**Staff Report: Ripley Street North (AKA Midtown Silver Spring)
Project Plan Amendment 92004006B
Preliminary Plan Amendment 12006054A
Site Plan Amendment 82006025A**

DATE: April 8, 2010

DESCRIPTION: Amend the Project, Preliminary, and Site Plans to increase the number of dwelling units from 314 to 385, increase the amount of retail space – as a proportion of the approved maximum density – from 5,380 to 5,541, change the building footprint and add a new building, modestly increase the amount of parking, and revise the public open space design, while maintaining the previously approved maximum buildable area, on 1.6 acres in the CBD-2 Zone; located on the north side of Ripley Street astride Colonial Lane, in the Silver Spring CBD Sector Plan.

Approved Site Design for Site Plan 820060250

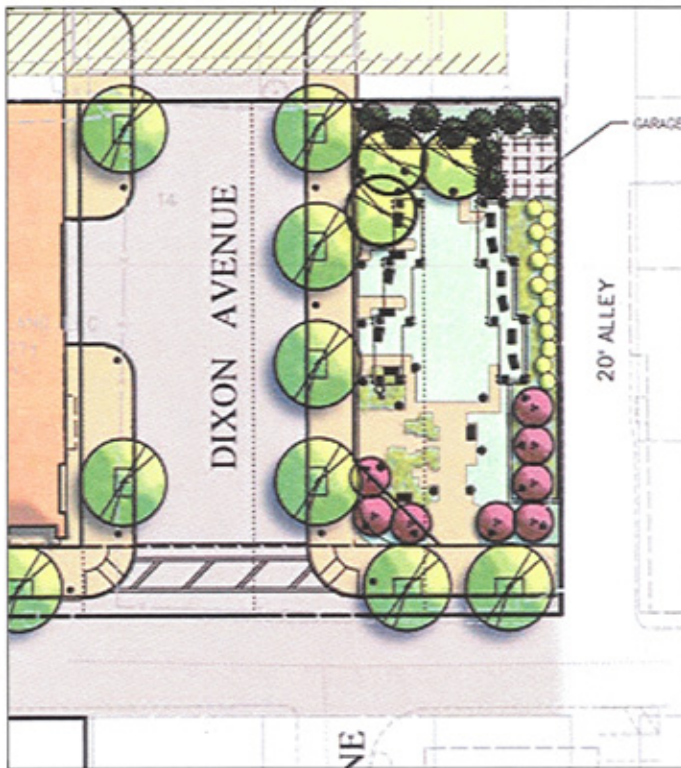
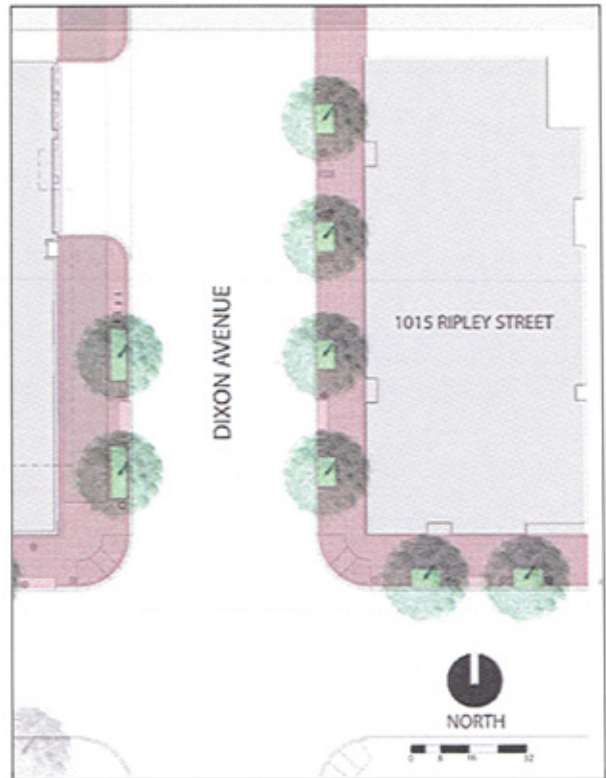
The originally approved design included two public spaces, one located on the western edge of the site and a second along the eastern edge, between Dixon Avenue and an existing service alley.

The public space on the eastern edge of the site was sandwiched between the new Dixon Avenue and an existing public service alley, and backed onto the public parking garage. The design for this space included a public art component themed on Rachel Carson and some seating areas. During the original Site Plan review, staff raised concerns about the activation and health of the park given two at least two non-active edges, and suggested alternative uses to more actively attract neighborhood patrons. The Applicant demurred, and staff included Condition 3.d., requiring minor changes intended to improve the usability of the design.

The proposed redesign replaces the eastern open space with a smaller-scale loft-type building with ground floor retail. This is a much better use of this site, with the potential to activate both Ripley Street and Dixon Avenue to serve both residents and pedestrian traffic moving to and from the metro station around the corner.
